Access Compliance Report

Public Rights-of-Way

(Curb Ramps)

Intersection ID: 15605	Main Street: GREYSTONE_RD	Cross Street: SOUTH_BV	Location: SW
ADA ID: 05E421F9AC2B	Ramp Type: Perp	Initial Pass/Fail: Fail	Overall Compliance: No
		Severity Score: 8.75	
Codes/Mitigation Info/Possible Solution		Field Measurements/Component Compliance

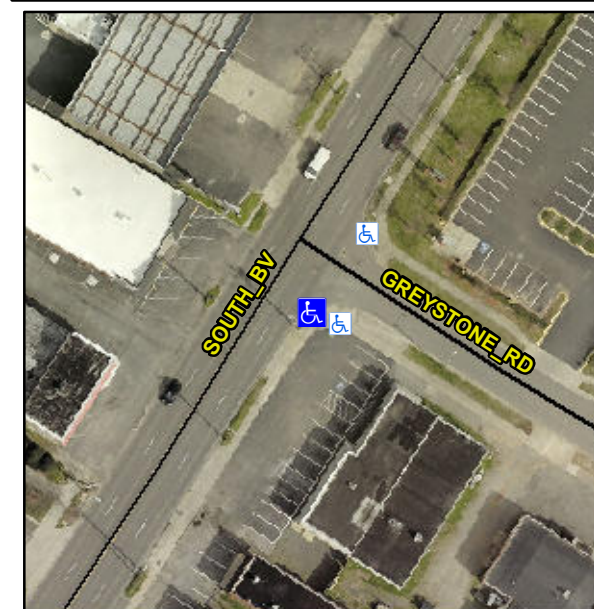
Not Found, R304.5.1

Compliance	Description	Data	Compliance	Description	Data
N/A	Ramp Length (in)	63.0	Yes	Ramp Slope (%)	7.2
No	Ramp Width (in)	36.0	Yes	Ramp XSlope (%)	1.3
N/A	Flare Type LT	N/A	N/A	Flare Type RT	N/A
N/A	Flare Slope LT (%)	N/A	N/A	Flare Slope RT (%)	N/A
N/A	Flare Traversable LT?	N/A	N/A	Flare Traversable RT?	N/A
N/A	Landing Length (in)	N/A	N/A	DWS Provided?	N/A
N/A	Landing Width (in)	N/A	N/A	DWS Contrast?	N/A
N/A	Landing Slope (%)	N/A	N/A	DWS Length (in)	N/A
N/A	Landing X Slope (%)	N/A	N/A	DWS Full Width?	N/A
N/A	Landing Curb? (Y/N)	N/A	N/A	DWS Offset (in)	N/A
N/A	Shared Landing?	N/A			
N/A	Gutter Ponding?	N/A	N/A	Gutter Slope (%)	N/A
N/A	Gutter Lip Ht (in)	N/A	N/A	Gutter X Slope (%)	N/A
N/A	Painted X Walk1?	No	N/A	Painted X Walk2?	N/A
	X Walk 1 Direction	To NE		X Walk 2 Direction	N/A
N/A	X Walk 1 Width (in)	N/A	N/A	X Walk 2 Width (in)	N/A
	X Walk 1 Slope (%)	1.1		X Walk 2 Slope (%)	N/A
	X Walk 1 X Slope (%)	1.1		X Walk 2 X Slope (%)	N/A

Remove & Replace Entire Ramp.
